Certified Action of the City of Raleigh Planning Commission

Case File / Name: SP-49-13 / West Apartments II

Nature of Case: This request is for a modification to a previously approved preliminary site plan. The modification includes developing the project in two phases, where the original plan only included one.

Staff Report

SP-49-13 West Apartments II – Preliminary Site Plan

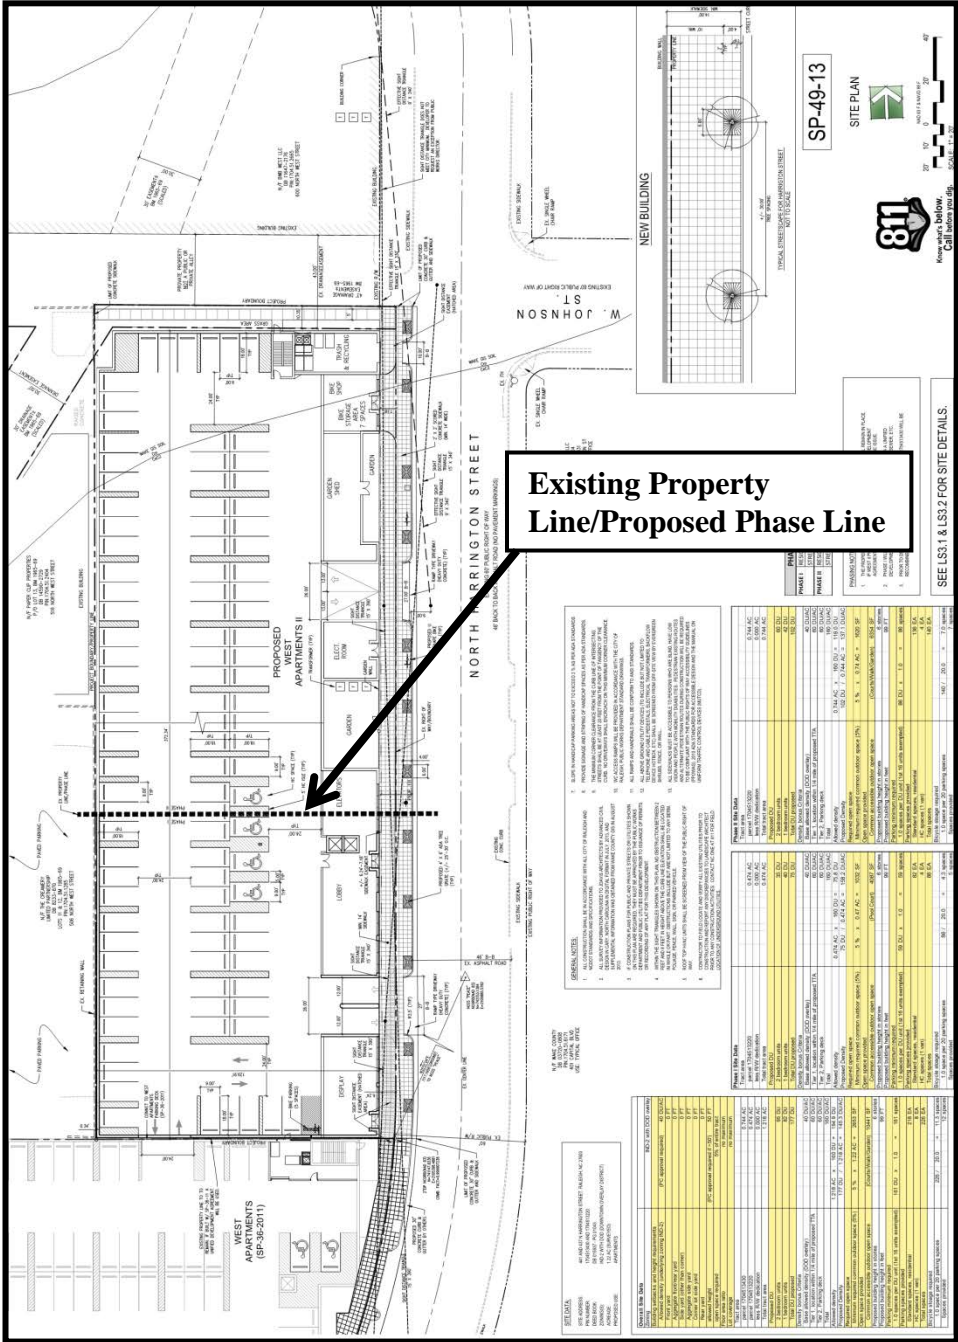
Comment	Response
The Commission commends the applicant’s addition of garden spaces, and encourages thoughtful connection as the building meets the sidewalk, considering the change of grade on site. The Commission also encourages a stronger physical and visual connection between the courtyards and sidewalk.	<i>We appreciate the positive response from the Appearance Commission in general. We also agree that the garden spaces, and common spaces have a strong connection and are aware of the challenges posed by the grade on Harrington Street. The garden spaces will be planted, and will be visible from the street.</i>
The Commission suggests additional detailing of the portions of the west elevation currently shown as scored stucco.	<i>We agree that additional detailing on the west elevation will be important. As shown on the elevations submitted with this response, and as the design</i>

<i>develops we will look at the possibility of adding signage and lighting to those faces of the building.</i>
The Commission suggests that the sidewalk on the northern edge of the site shown in the easement be extended to the western property boundary to offer residents a more direct connection to the west. The Commission also suggests a visual cue such as an awning to indicate the presence of this mid-block path.	<i>A sidewalk will be added, however, this is not a public right of way, so pedestrian access will ultimately be on Harrington Street as it connects to West Street.</i>
The commission suggests the use of additional stucco rather than Hardipanel on the front plane of the building and that the applicants consider tightening the color palette.	<i>Additional stucco will be substituted for Hardipanel as the design develops, and as shown on the revised elevations included with this submittal. The color scheme will also be evaluated further.</i>

The Commission suggests the use of additional lighting, street furnishings, and further detailing of the courtyard in an effort to enliven the ground level experience.	<i>We agree that additional elements will enhance the streetscapes and courtyards. These will be studied as the design develops.</i>
The commission suggests that the Harrington Street entrance be further accentuated.	<i>The entry to the building on Harrington is accented through the use of materials, form, and color. It is a secondary entrance to the project, so the design needs to balance it's importance on Harrington Street, with the main entrance on West Street.</i>
The Commission commends the applicant's creative use of ground floor space, and encourages additional spaces throughout the larger development to provide amenity for the residents and to enliven the ground floor experience.	<i>We appreciate the Commission's support of this project.</i>
